CONVAIR

COMMERCIAL CHANGE PROPOSAL

SPEC NO.: ZD- 22-002

MODEL: 22-1 (Convair "880")

Page 61A, FIGURE 3.14--1 PILOT'S AND COPILOT'S INSTRUMENT PANELS:

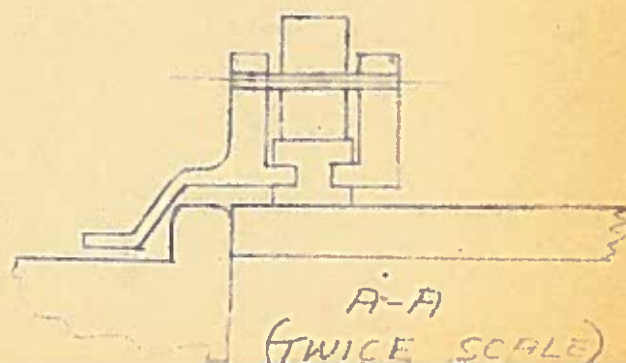
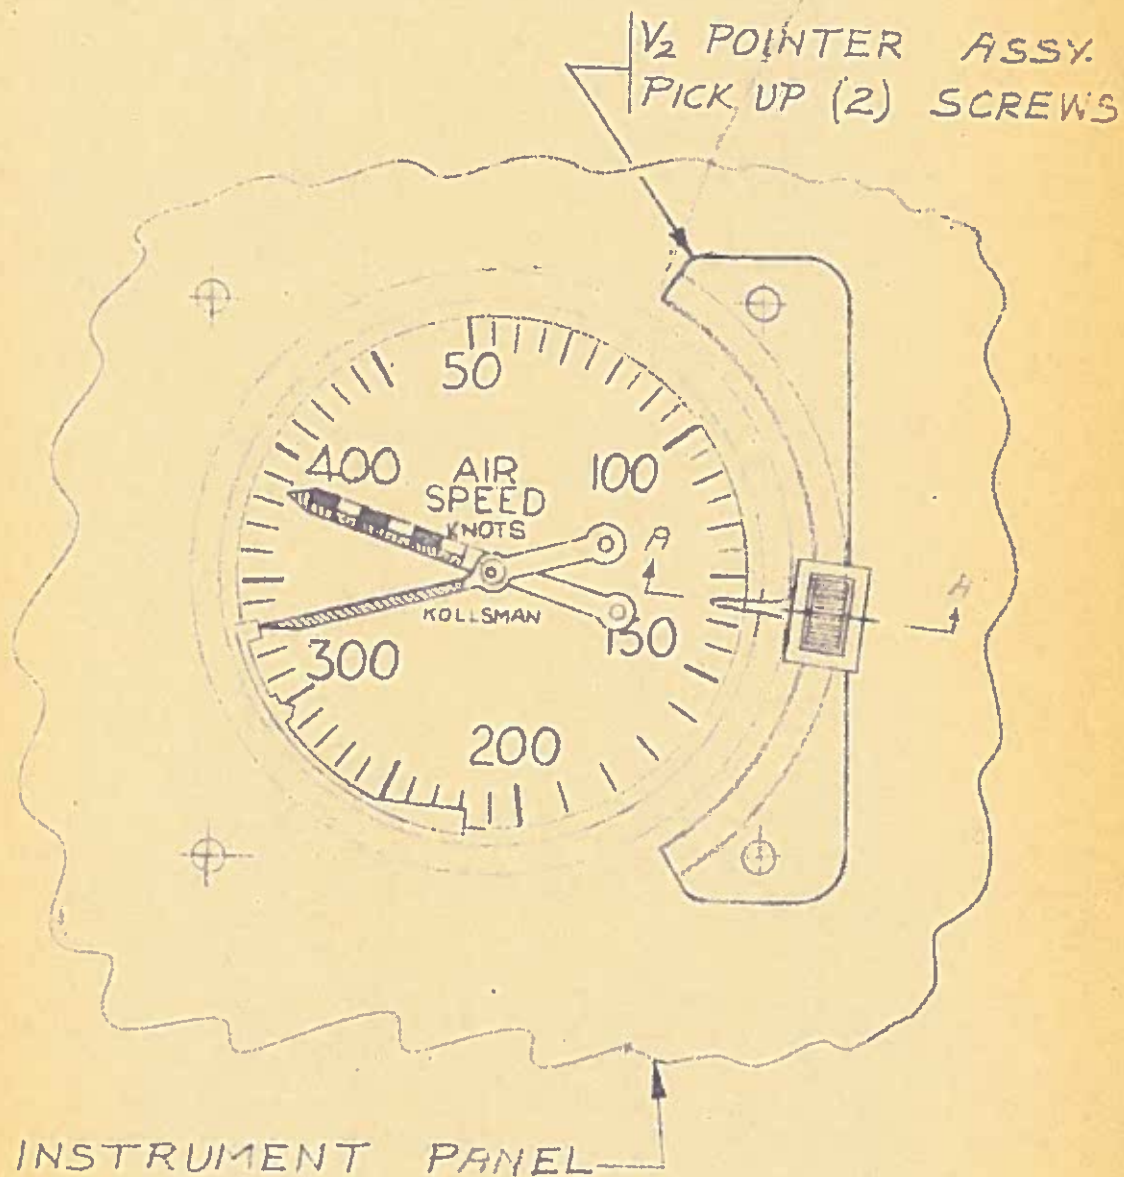
Revise above illustration by adding settable V_2 index pointer for airspeed indicator.

"2 Settable V_2 Index Pointer for
Airspeed Indicator (P/N to be supplied)"

Enclosure: (A) One copy Page 54A - ENGINE STARTING SYSTEM (Revised).

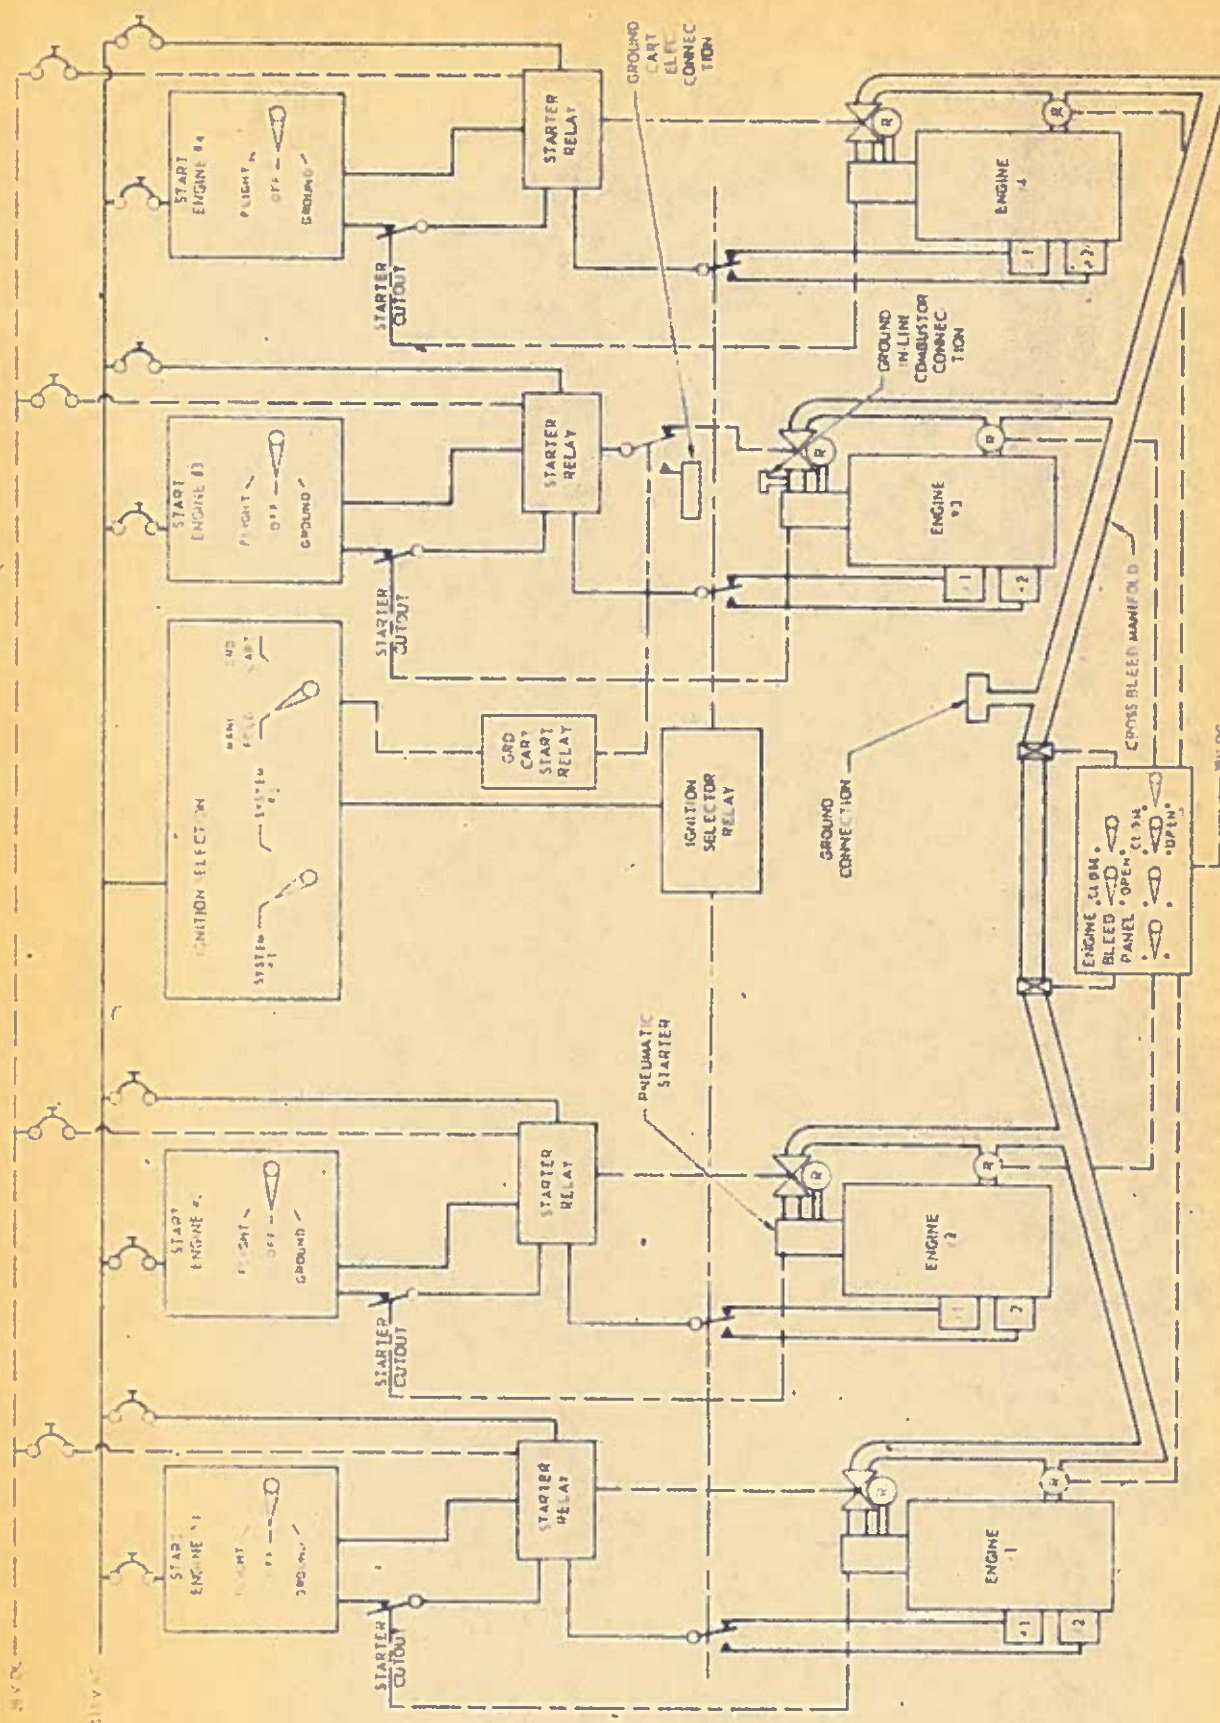
Delete the entire paragraph, including paragraph number and title.

FIGURE 3.14-6

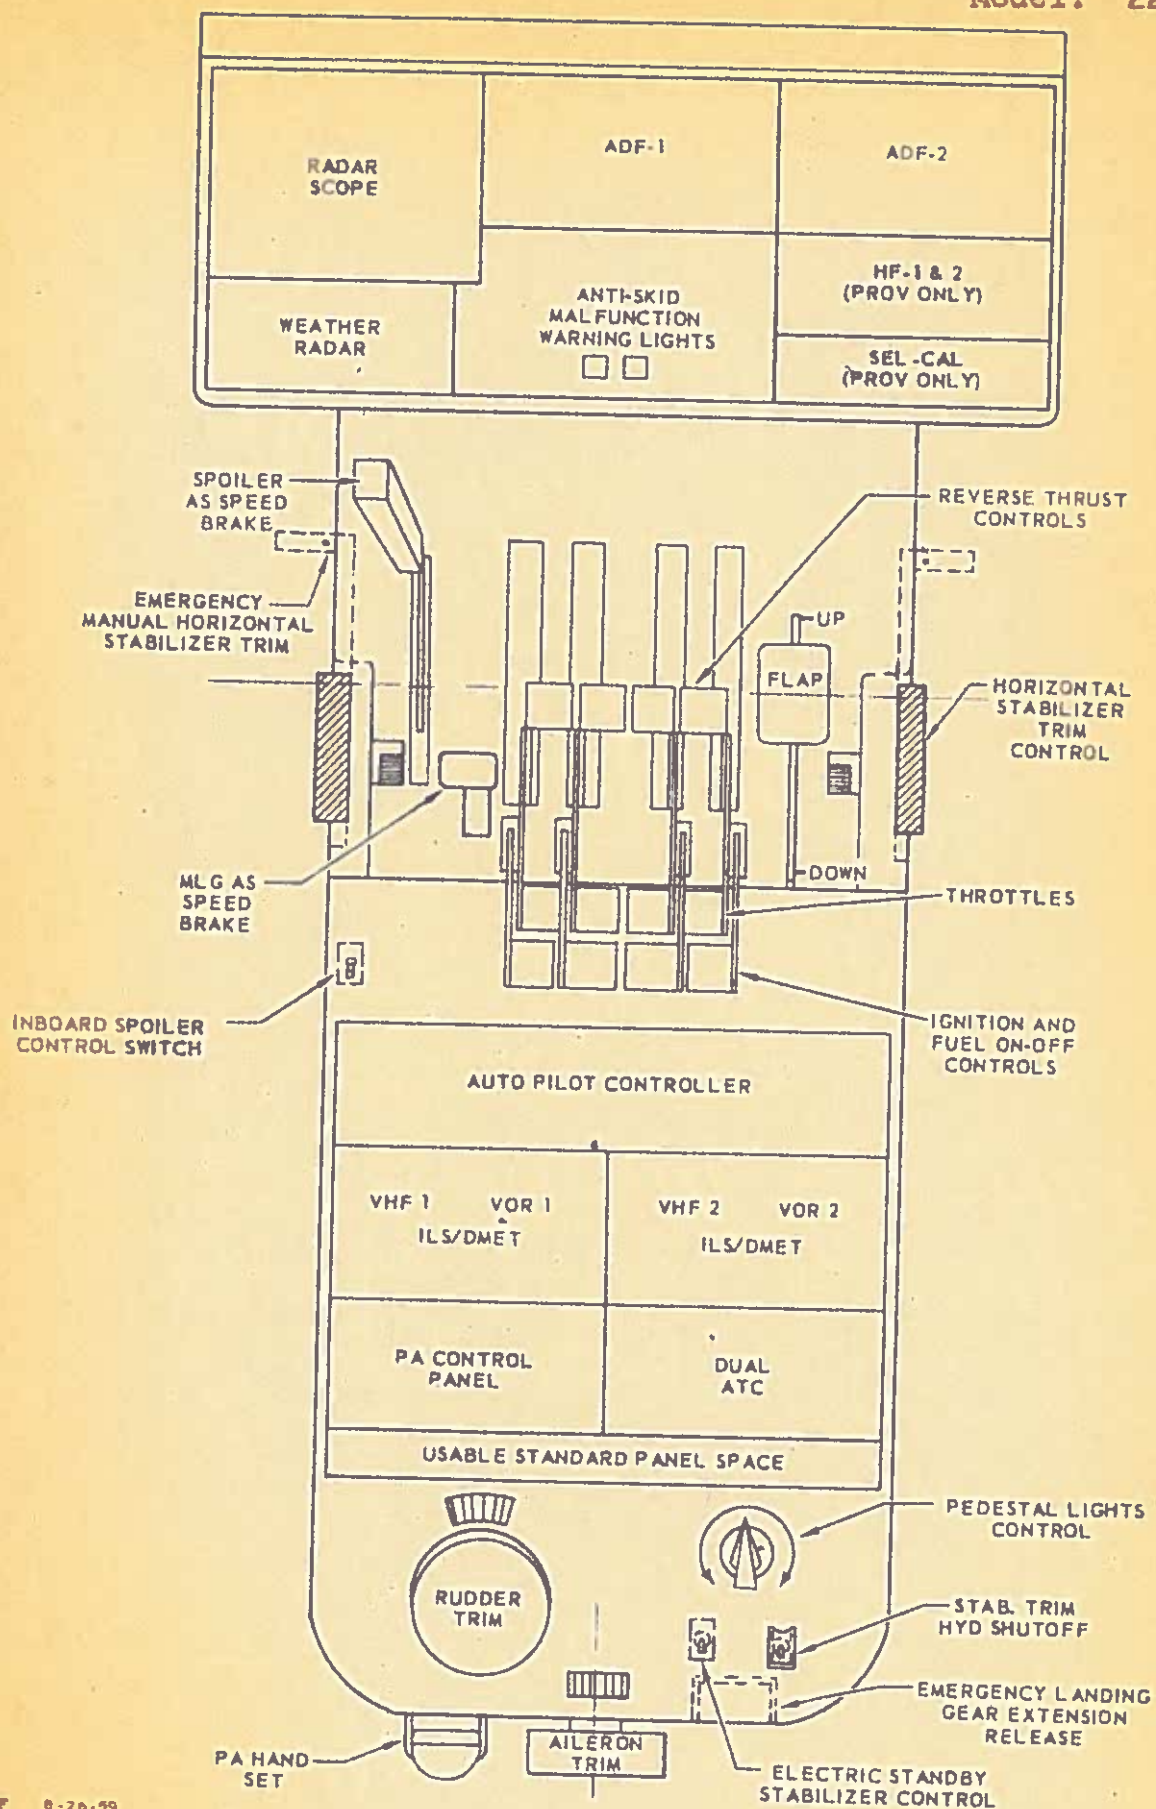
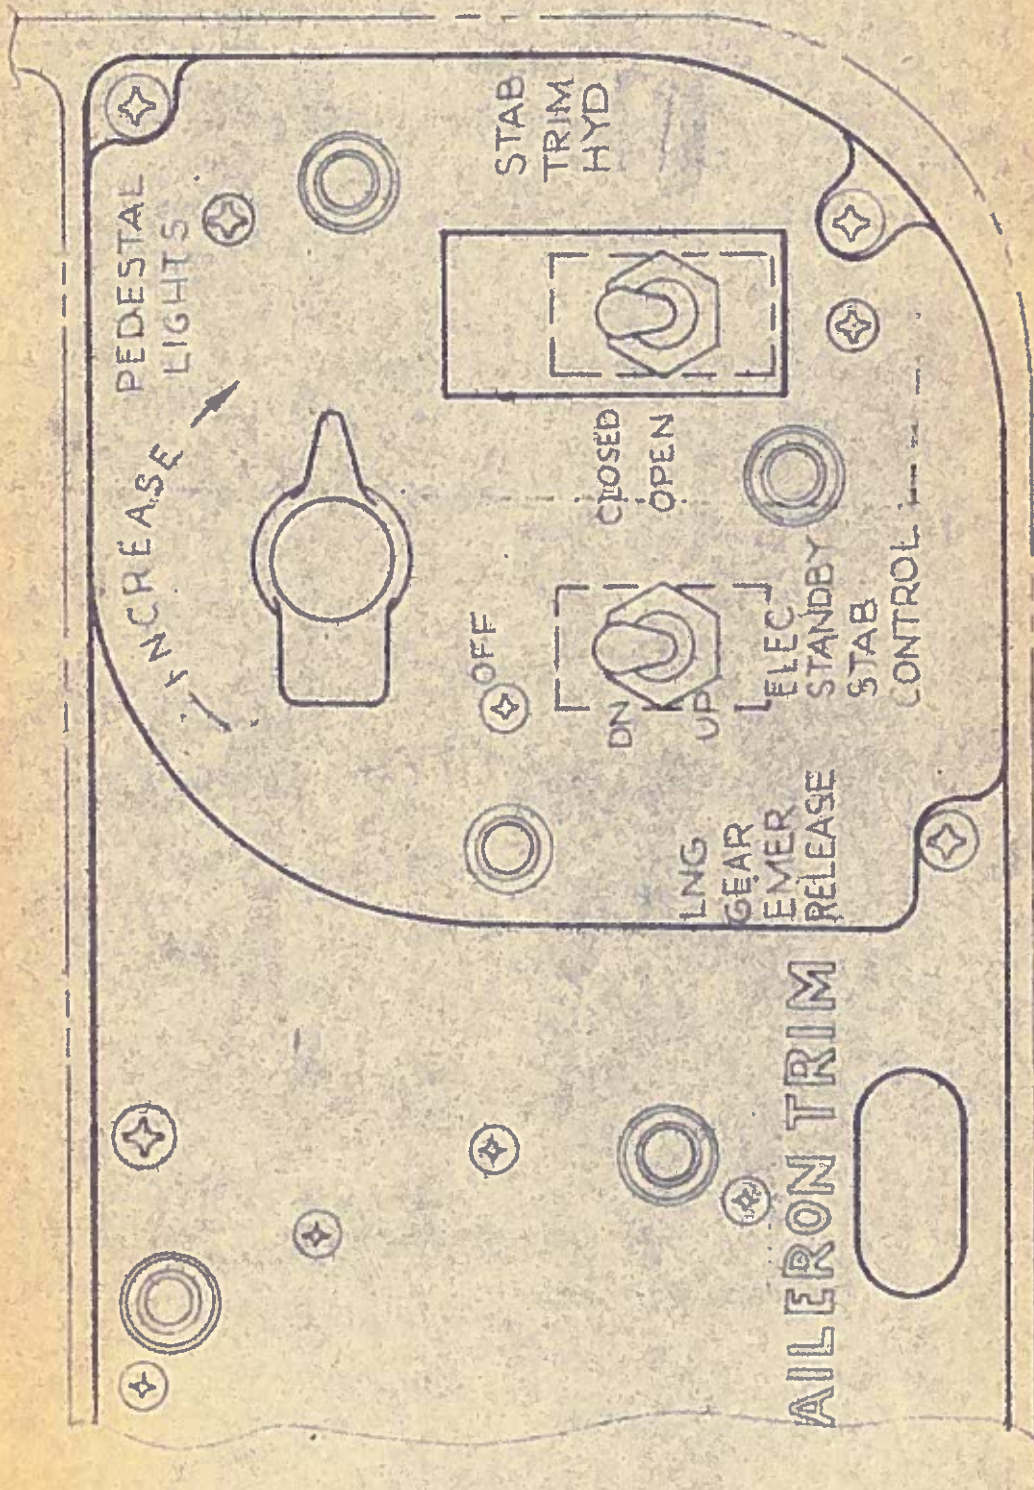
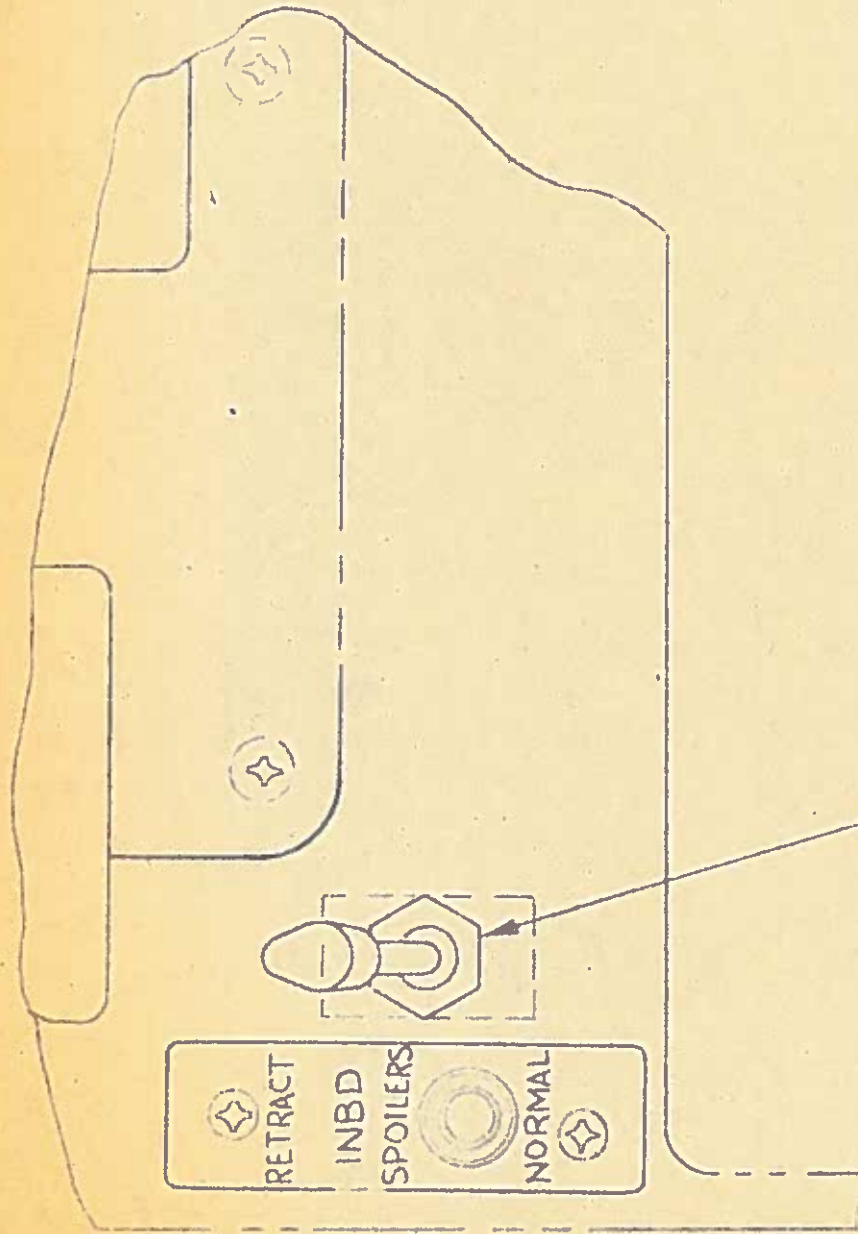
Page 104A, Figure 3.17-1 PILOT'S AND COPILOT'S PEDESTAL:

- Enclosures: (A) One (1) copy of Figure 3.14-6 PILOT'S AND COPILOT'S PEDESTAL
- (B) Convair Sketch showing labeling of Electric Standby Stabilizer Control and Stabilizer Hyd.
(For information only.)
- (C) Convair Sketch showing labeling of Inboard Spoiler Switch (for information only.)

Page 2A, Figure 1-1 GENERAL ARRANGEMENT:

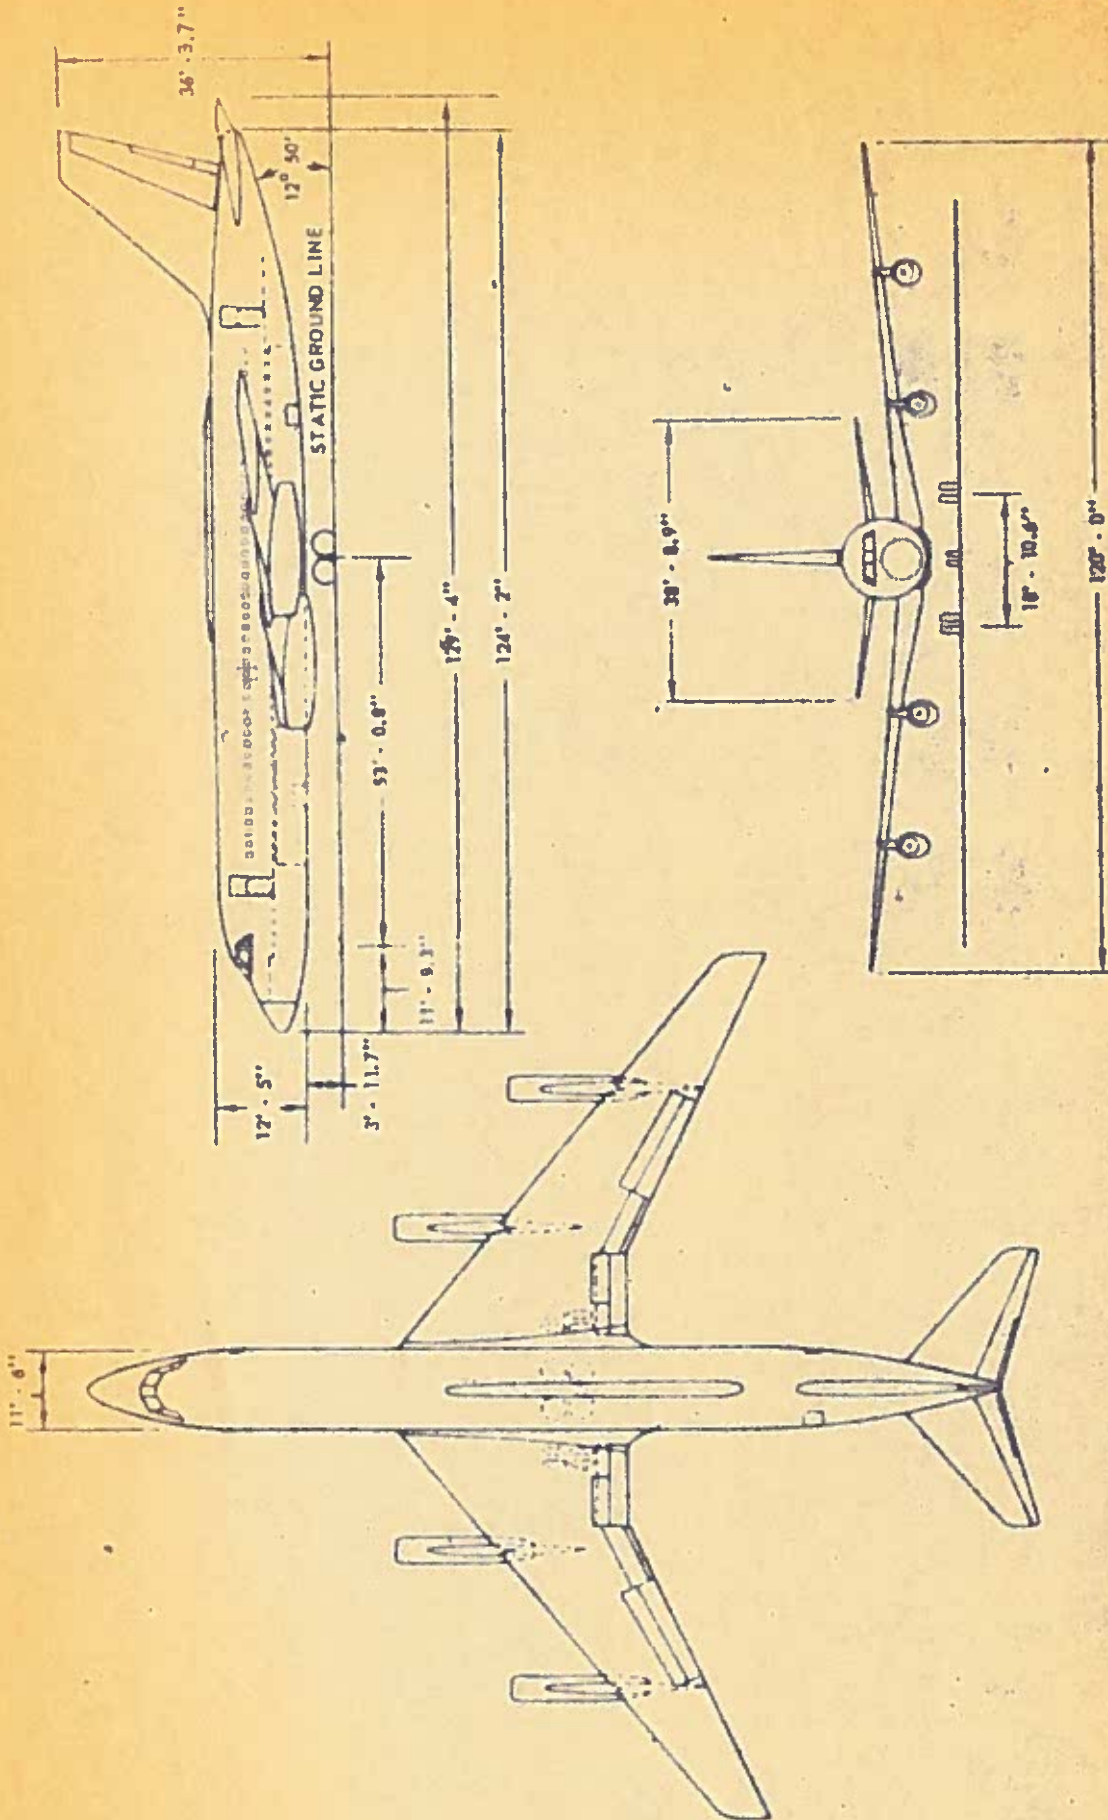
Change the following items in the equipment list:

<u>From:</u>	2 Pilot's Safety Belt and Shoulder Harness		
	1 Flight Engineer's Safety Belt and Shoulder Harness		
	2 Stewardess Safety Belt and Shoulder Harness		
<u>To:</u>	2 Pilot's Safety Belt and Inertia Reels Including Shoulder Harness	Pacific Scientific	0101145-0
	1 Flight Engineer's Safety Belt and Inertia Reel Including Shoulder Harness	Pacific Scientific	0101146-0
	3 Stewardess' Safety Belt and Shoulder Harness

Add the following items to the equipment list:

1 Observer's Seat
